SHEARON HARRIS NUCLEAR POWER PLANT
DOCKET NO. 50-400/LICENSE NO. NPF-63
CYCLE 11 CORE OPERATING LIMITS REPORT

SUMMARY OF CYCLE 11 COLR REVISIONS

Harris Unit 1 Cycle 11
Core Operating Limits Report - Rev. 0

Figure 2

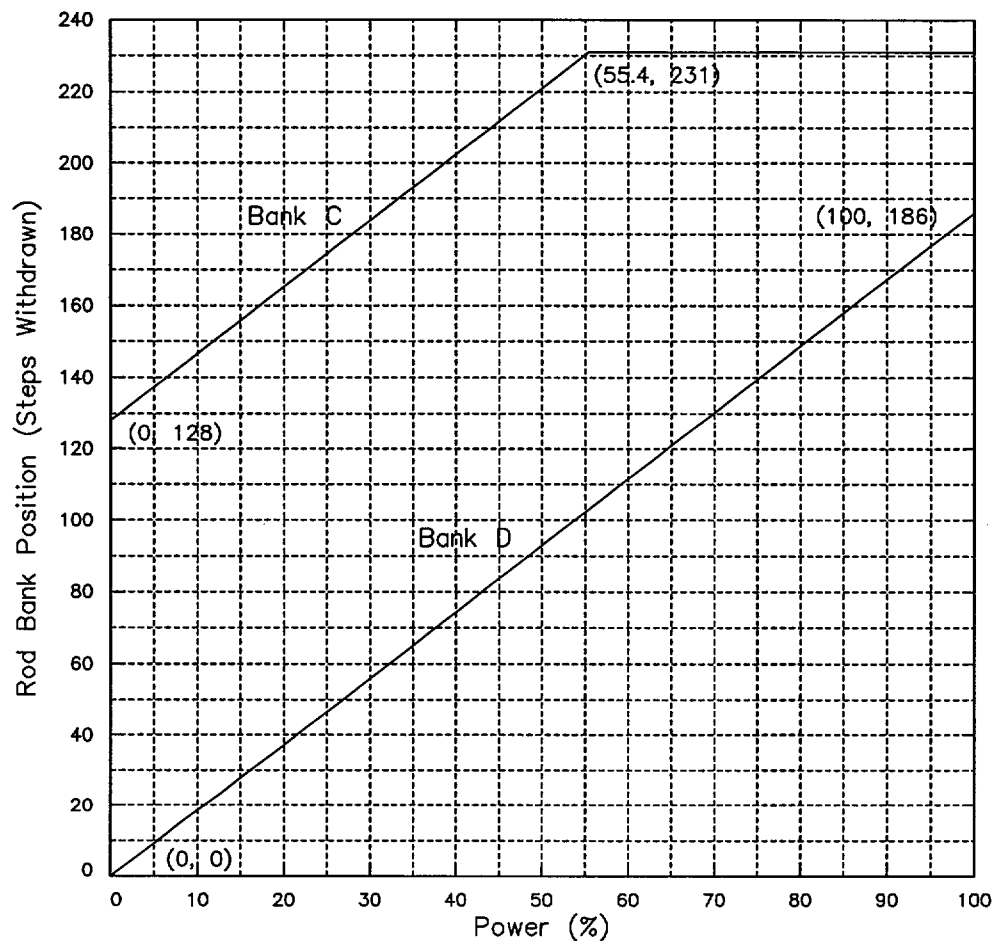
<u>Section</u>	<u>Description of Change</u>	<u>Reason for Change</u> <u>(see Notes)</u>
3.9	Deleted previous references 9, 10 & 11 (WCAP-9272, WCAP-10266, and WCAP 11837), and renumbered remaining references.	2
Figure 2	Changed Figure 2 to reflect the new rod park position of 231 steps for Cycle 11.	1
Figure 5	Changed Figure 5 to reflect the V(Z) curve for Cycle 11 operation up through 16000 MWD/MTU.	1
Figure 6	Changed Figure 6 to reflect the V(Z) curve for Cycle 11 operation for burnups from 16000 MWD/MTU through 20520 MWD/MTU.	1

(Fully withdrawn shall be 231 steps)
